Item Name: Crosstube Turning Detail

DART AEROSPACE LTD	Work Order:	157849
Description: Crosstube Assembly	Part Number:	D407-667-145
Inspection Dwg: D407-667-145 Rev: C		Page 1 of 2

DRAWING NO. D407-667-145	TITLE CROSSTUBE ASS'Y (407 HIGH FWD)	REV. C	DART AEROSPACE LTD ENGINEERING ORDER		D.E.O. NO. D407-667-145-C-1	SHEET NO. SHEET 1 OF 1	SCALE NTS
DRAWN <i>qp</i>	CHECKED <i>ASS</i>	MFG. APPR. <i>IB</i>	APPROVED <i>WD</i>		DE APPR. <i>th</i>		
DATE 11.07.15	DATE 11.07.22	DATE 11.07.22	DATE 11/07/22		DATE 11.07.21

DRAWING NO. D407-667-145	TITLE CROSSTUBE ASS'Y (407 HIGH FWD)	REV. C	DART AEROSPACE LTD ENGINEERING ORDER	D.E.O. NO. D407-667-145-C-2	SHEET NO. SHEET 1 OF 1	SCALE NTS
DRAWN AJS	CHECKED A	MFG. APPR. B	APPROVED 140	DE APPR. 140	DATE 12.08.02	DATE 12.08.02

DETAIL P
BONDING STRAP INSTALLATION 2 PL

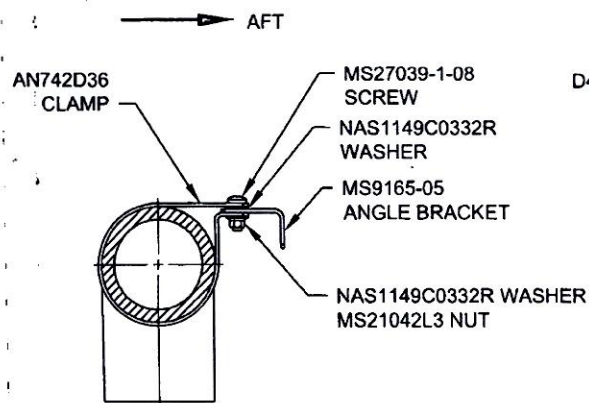
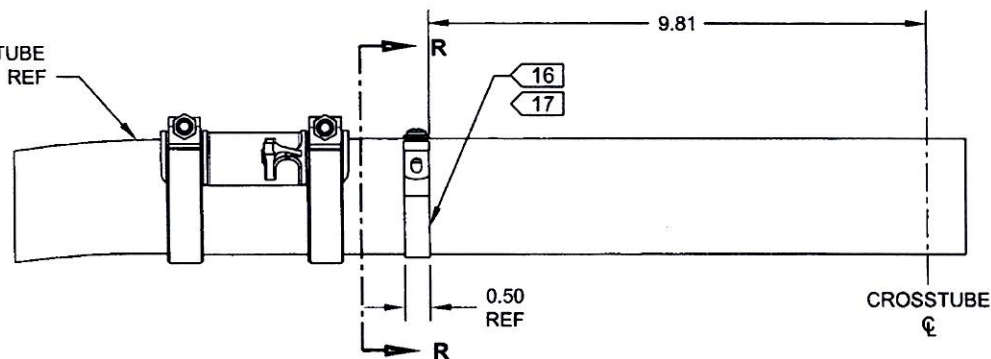
ADD ELECTRICAL GROUNDING STRAP

ITEM	QTY -145	PART NUMBER	DESCRIPTION
1	X	D407-667-145	CROSSTUBE ASSEMBLY (407 HIGH FWD)
10	2	AN742D36	CLAMP
11	2	MS9165-05	ANGLE BRACKET
12	2	MS21042L3	NUT (OR MS21042-3)
13	2	MS27039-1-08	SCREW
14	4	NAS1149C0332R	WASHER (OR AN960C10L)

- 16) MASK AREA UNDER CLAMP PRIOR TO PAINTING
- 17) SEAL EDGES WHERE AN742D36 CLAMP MEETS WITH THE CROSSTUBE USING SIKAFLEX-241/-291 OR MIL-S-8802 CLASS B2 OR PROSEAL 890 SEALANT
- 18) PERFORM RESISTANCE CHECK TO ENSURE MAX RESISTANCE IS 10 MILLIOHMS
